Title of Change:	Enhanced and more detailed description of the NCV7685 behavior inside of the datasheet. Highlight of important parameters for correct startup.	
Effective date:	08 Aug 2023	
Contact information:	Contact your local onsemi Sales Office or Ladislav.Bazant@onsemi.com	
Type of notification:	This Product Bulletin is for notification purposes only. onsemi will proceed with implementation of this change upon publication of this Product Bulletin.	
Change Category:	Datasheet change	
Change Sub-Category(s):	Datasheet/Product Doc change	
Sites Affected:		
onsemi Sites		External Foundry/Subcon Sites
None		None

Figure 4. Application Diagram with Micro-controller (I²C Mode)

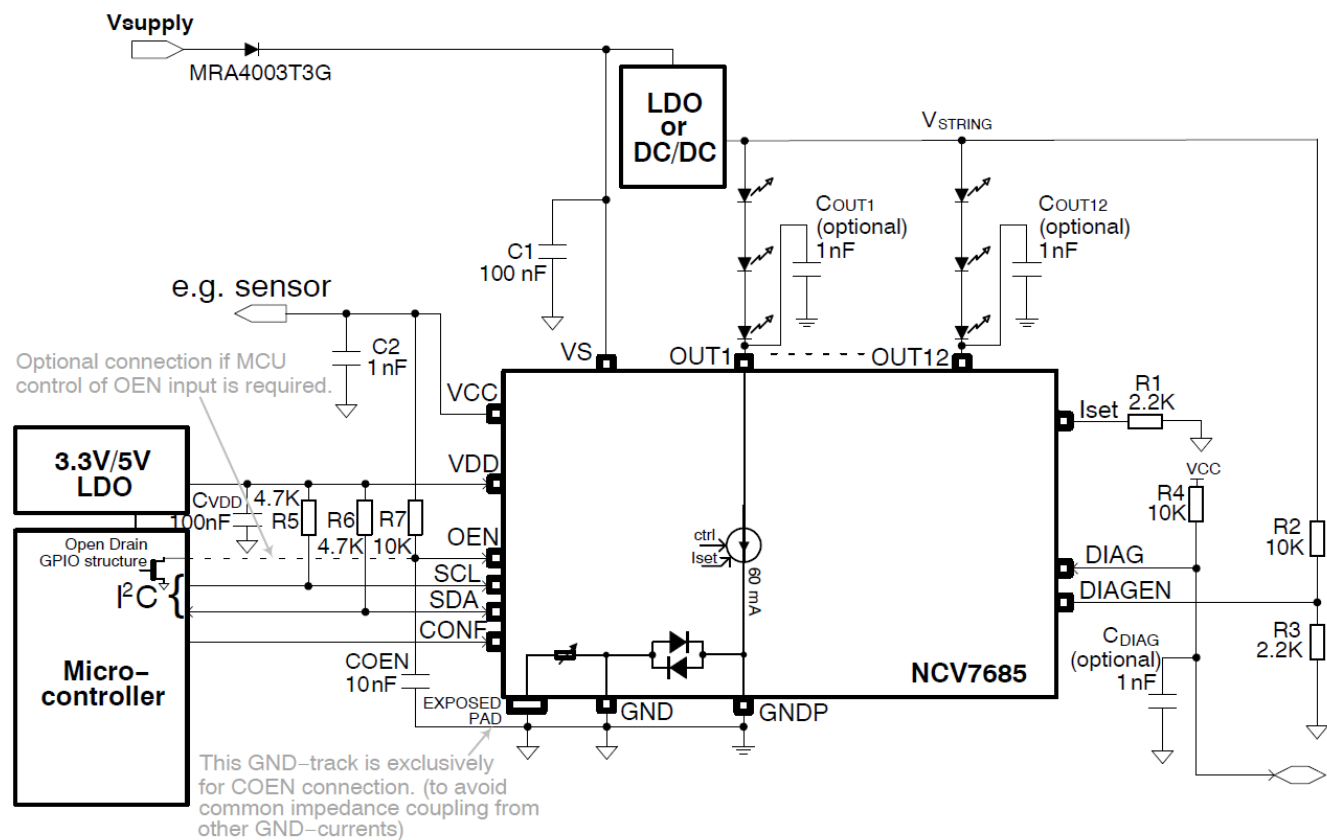
- **Adding supporting text to the Application Diagram for Figure 4.**
 - Text describes how to start up the NCV7685 device in the I2C mode
 - New text below the Figure 4.

The device is powered-up with both VS and VDD. Both must be in the recommended operating range.

- At power-up, the device loads the selected SAM register. (like in Stand Alone Mode)
- Because VDD is supplied, communication through the I²C lines (SCL-and SDA-pins) is allowed
- I²C mode must be activated by setting I2CFLAG in the I2C_CONF register.

NOTE: The NCV7685 may not start-up when VDD is kept between 1 V and VDDUV_R (2.9V)
